City of Henderson
Fire Safety Engineering
Informational Bulletin

Issue 014

COMMON ERRORS ON SPRINKLER DRAWINGS (PART 2 OF 2)

Arrangement of Sprinklers Under Two Sets of Open Joists - No Sheathing on Lower Joists.

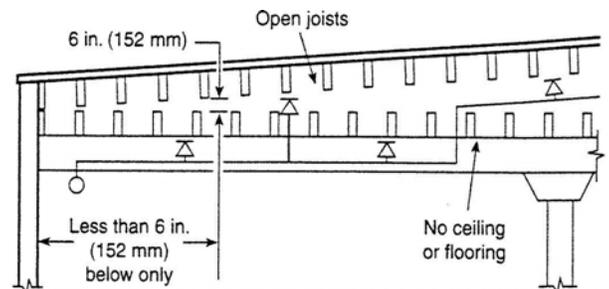
9. Attic coverage (upright heads) along roof trusses shall extend from the peak to the end of the truss, not to the point where the space between the top and bottom cords is $> 6"$ clear.
